MBS/MCS/MBD Series Automation Control Systems

Catalog Design Change Notification

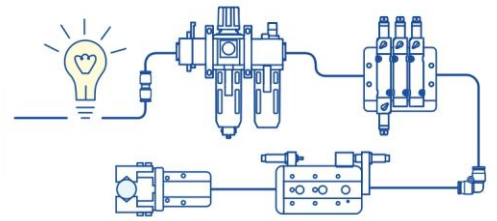
- a. We will change the sequence of ordering number to avoid confusion with the accessories "plug" of MBS series solenoid.
- b. MBS-*-T and MCS-*-T series cancel the accessory Y-plug : #2 Wires.
Because it cannot be used with a timer.
- c. MBS-*-T and MCS-*-T series add a new accessory : Y-type strainer.
- d. Add the Y-type strainer installation schematic.
